Highgate Municipal Building: ADA Compliance Evaluation

ARNOLD & SCANGAS ARCHITECTS

Back Entrance: Non-Accessible Entrance

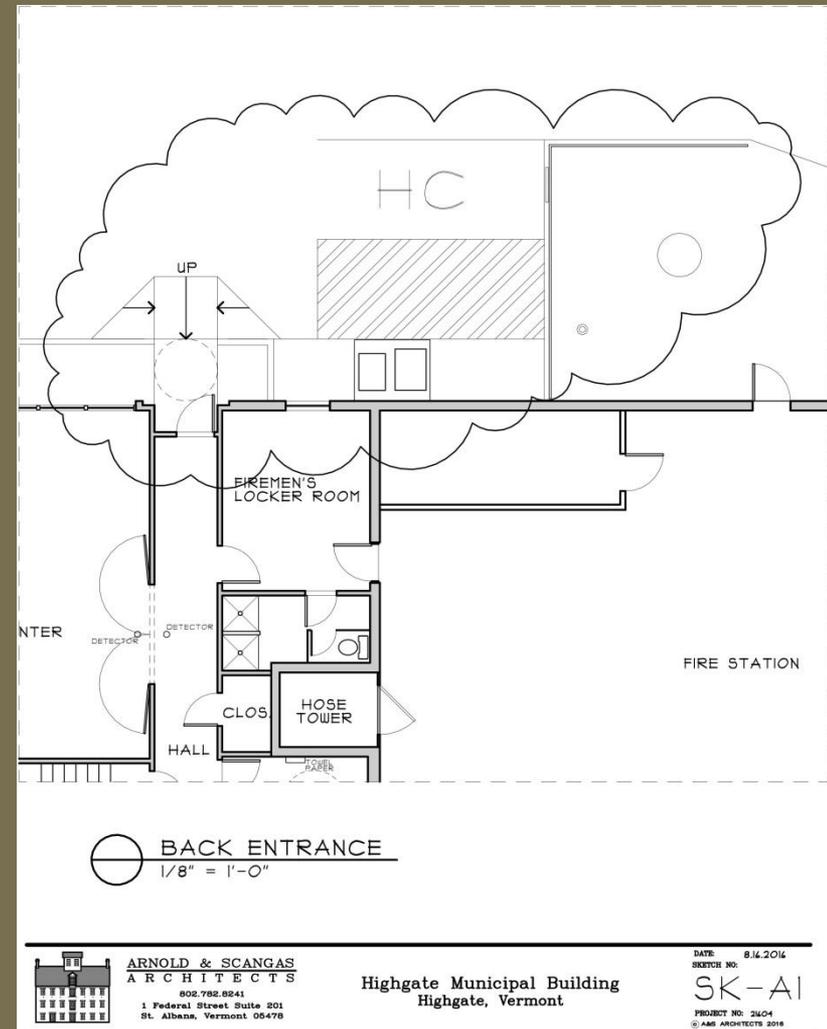
- The rear entrance is locked during the day and cannot be use independently during the same business hours as the front entrance.
- The rear entrance does not contain a sign with the international symbol of accessibility, indicating that this is the accessible entrance.
- The landing in front of the exterior entrance is not level and has a number of changes in elevation, the total change in height is approximately 6" from finish floor to top of pavement.
- The existing entrance door at the exterior does not have the required 4'-0" clearance depth.
- The accessible entrance has a curb that protrudes out of the ground more than 1/4"

- Relocate accessible parking space to allow for a van accessible aisle that is not in the designated path of travel
- Provide a “van accessible” sign for the space where the bottom of the sign is at least 60” off grade.
- Reconfigure exterior door landing to allow for a level 5’-0” turning radius landing at doorway.
- Provide a curbed ramp with curb ramp flares
- Provide sign at front entrance stating the accessible entrance is located in the rear of the building.
- Allow accessible entrance to be used independently during regular business hours.
- Provide new sign with the international symbol of accessibility.

Front Entrance: Non-Accessible Entrance

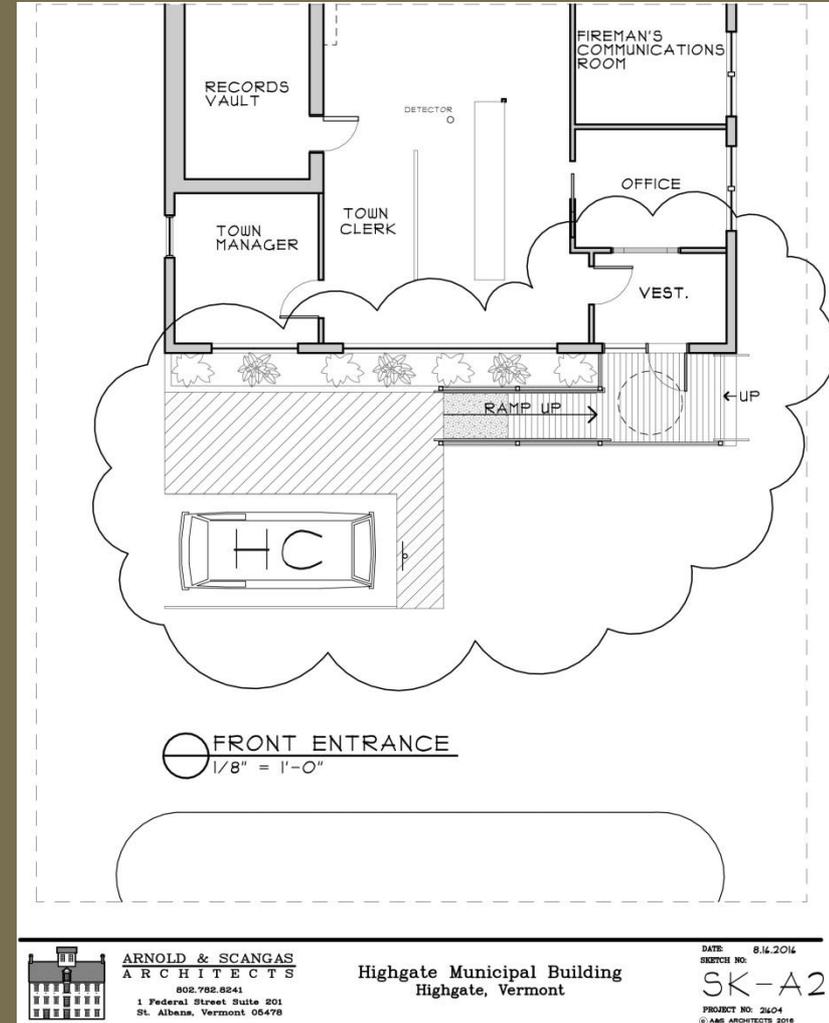
- There is an approximately $\frac{3}{4}$ " vertical change of level at the existing exterior door threshold. A $\frac{3}{4}$ " change is allowed for existing thresholds, however the vertical face on the threshold may not exceed a $\frac{1}{4}$ ", above that height thresholds must be beveled.
- The existing interior vestibule does not have a 5'-0" turning radius
- At the interior of the existing vestibule door, there is not the required 1'-6" clearance from the latch side of the door to the corner
- There is an approximately $\frac{1}{2}$ " vertical change of level at the existing interior vestibule door threshold. A $\frac{3}{4}$ " change is allowed for existing thresholds, however the vertical face on the threshold may not exceed a $\frac{1}{4}$ ", above that height thresholds must be beveled.

- Provide a new van accessible parking space including a van accessible aisle
- Provide a “van accessible” sign for the parking space where the bottom of the sign is at least 60” off the grade.
- Provide an accessible ramp with railings from the accessible parking space side and stairs with railings from the fire station side.
- Remove a portion of the exterior vestibule wall to provide the 5’-0” turning radius at the interior of the vestibule and to provide 1’-6” clearance at the pull side of the interior vestibule door.
- Provide new ADA accessible thresholds at both the exterior and interior doors

Doors: Sizes, Door Maneuvering Space & Hardware

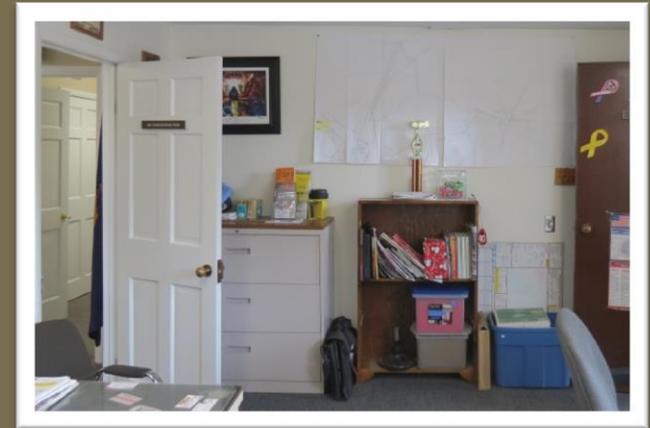
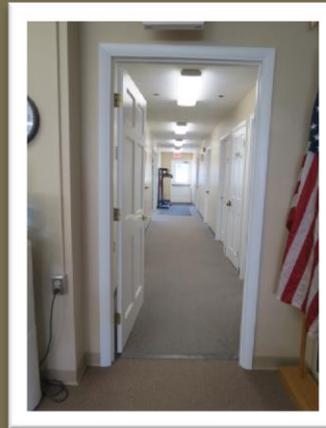
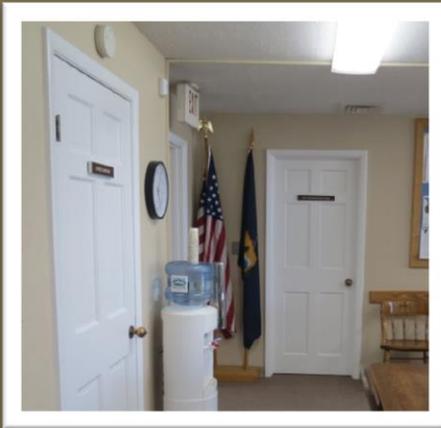
- Existing 2'-6" wide doors do not meet requirements of a 2'-8" clear opening with the door fully opened.
- The existing doorway separating the accessible hallway and the reception area has a 16" clear space on the pull side of the door, which does not meet the required 18".
- Existing door hardware includes a mix of compliant lever handles and non-compliant knob-type handles.
- Existing door closers do not meet the closing speed for ADA.

Reception Counter: Accessible Counter Space

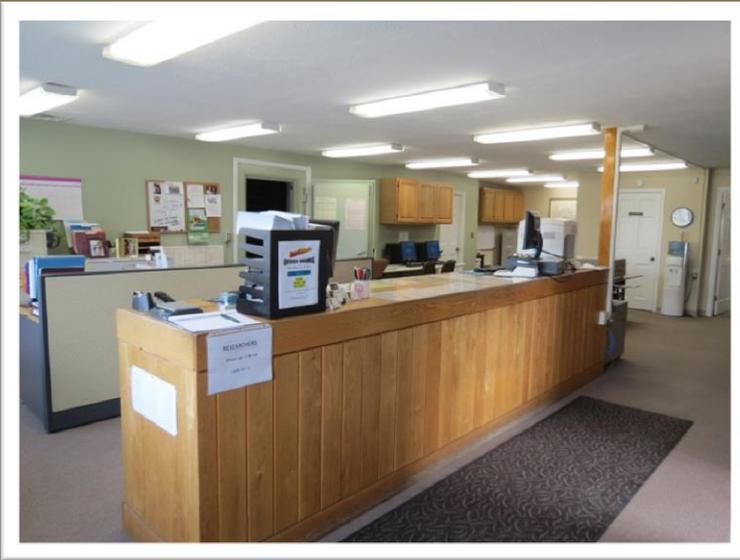
- The existing Reception Counter is 42" high and does not provide a section of counter that meets ADA accessible requirements.

- A section of this counter or a fold-down counter needs to be provided for a wheelchair user to be able to transact business and have a writing surface that is at a reasonable height. This should be no more than 36" high and should be at least 36" wide. An accessible service shelf should be at least 19" deep to permit appropriate knee clearance.
- Sales and Service Counters should have a height between 28" and 34" and at least 36" wide.
- An equivalent service area may be provided at a nearby table with sufficient wheelchair clearances.

Men's and Women's Bathrooms: Doors Clearances & Maneuvering Space

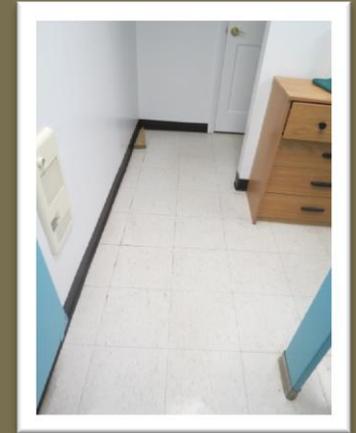
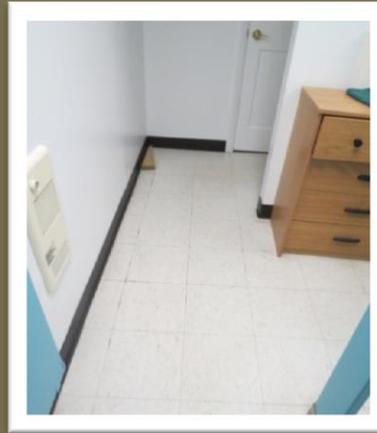
- The existing privacy wall does not allow 48" clear from the door to the wall and doesn't allow 48" between the end of the privacy wall and the bathroom wall.
- The existing door closers do not meet the required ADA closing speed.
- In the existing bathrooms, a 5'-0" turning radius is not provided

Men's and Women's Bathrooms: Sinks, Mirrors, Paper Towels and Toilet Paper

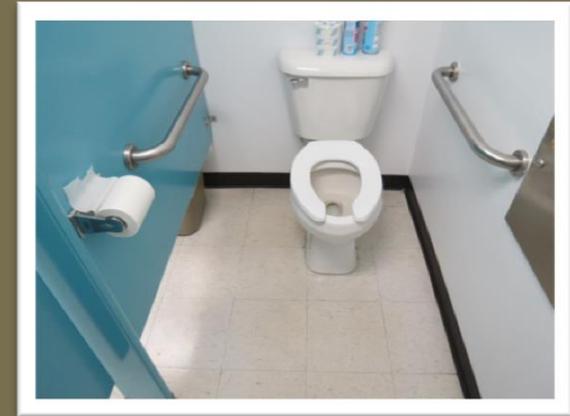
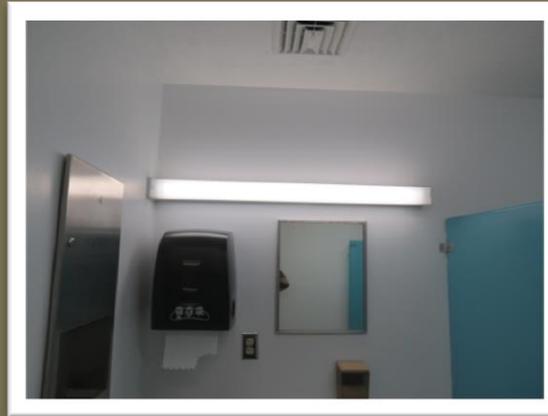
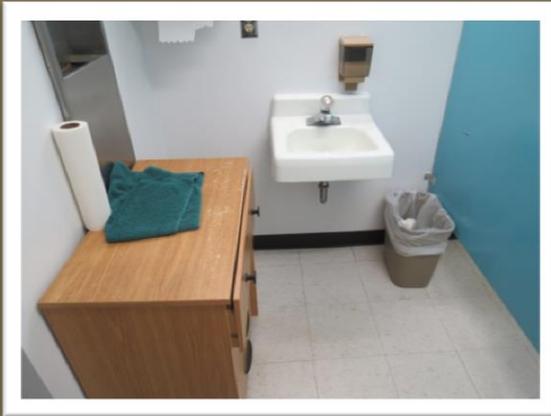
- The existing wall mounted sinks are mounted to low above the floor and the existing exposed piping under the sink is not insulated and protected
- The existing knob faucets are non-complaint
- The existing mirrors, paper towel dispensers and receptacles are too high off the floor.
- The existing toilet paper dispenser is placed at least 12" away from the front edge of the toilet.

Men's and Women's Bathrooms: Stalls & Toilets

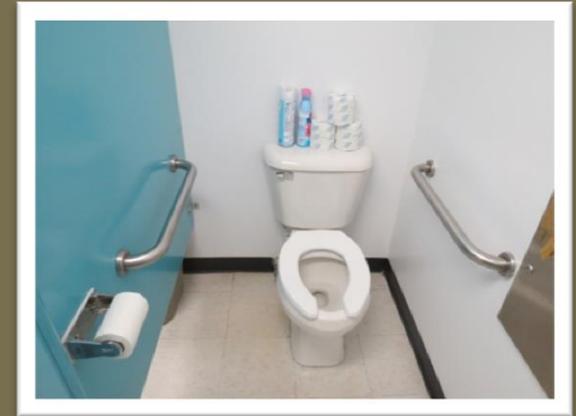
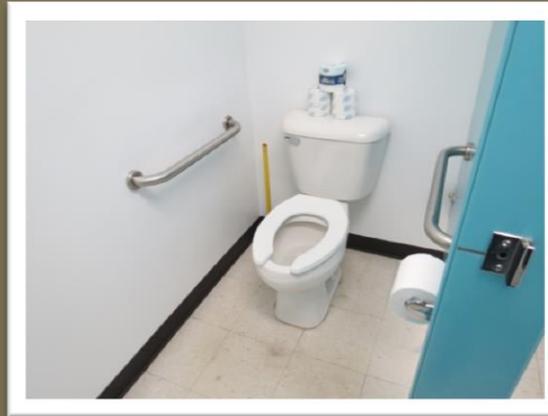
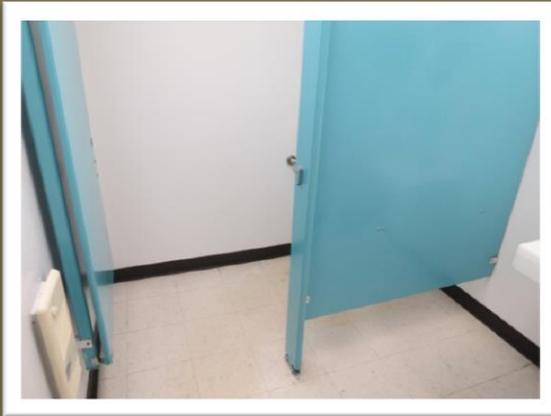
- The existing stall does not meet the minimum size (5'-0" wide by 4'-11" wide)
- The existing grab bars are non-complaint
- The existing stall doors do not provide a minimum of 32" clear door space and the door lock is non-complaint
- The existing flush handle for the toilet is on the wrong side of the toilet.

Use of Second Floor: Public Meetings, Private Offices and Means of Egress

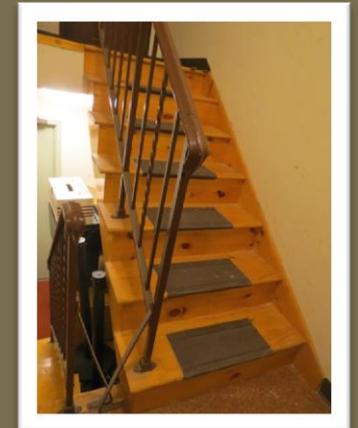
- The previous passage in the Title II requirements would affect the second floor since no ADA access is currently provided. Any meeting that can be attended by the public would not be able to occur on an inaccessible floor, since access to any public meeting must be provided to all and any with a disability. Along those lines, any office space that would be used by a town official that interacts with the public would also have to be accessible to anyone with a disability. This would mean that ADA access would have to be provided to the second floor. The code does allow for some flexibility in existing building intending to comply, in this case, providing a separate but equal space.

Masterplan: Existing

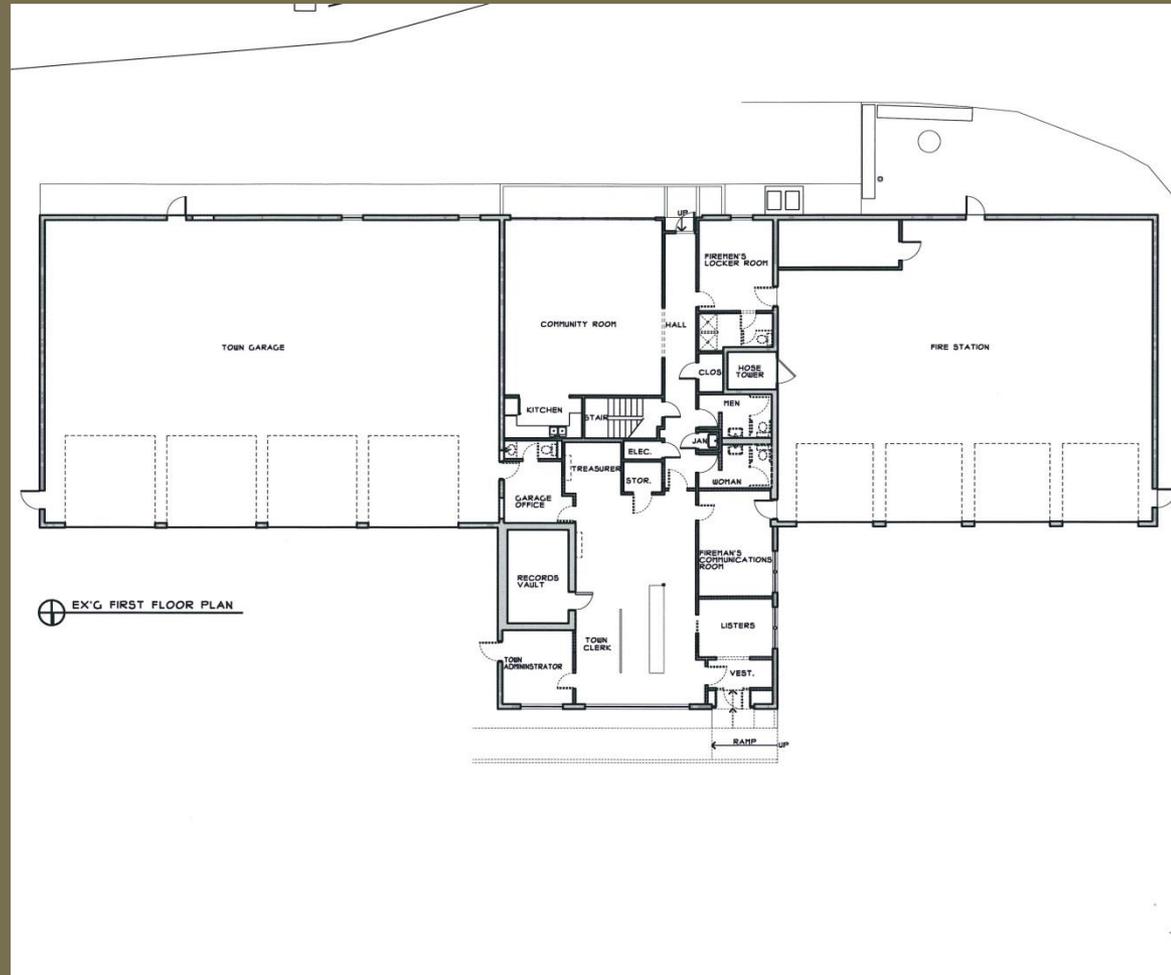
- Back Entrance
- Front Entrance
- Door, Sizes, Door Maneuvering Space and Hardware
- Reception Counter
- Men's and Women's Bathrooms
- Signage
- Provide adequate room for employees
- Main office flow is clumsy and noisy
- Listers office is small
- Treasurer does not have an office
- Fire Department has a large office
- Town Garage office and bathroom
- Town Garage work/breakrm in garage
- Town Garage needs additional storage
- Fire Department locker room and bath/showers
- Files stored in community room
- Exterior door at Town Administrator's office, remove or replace
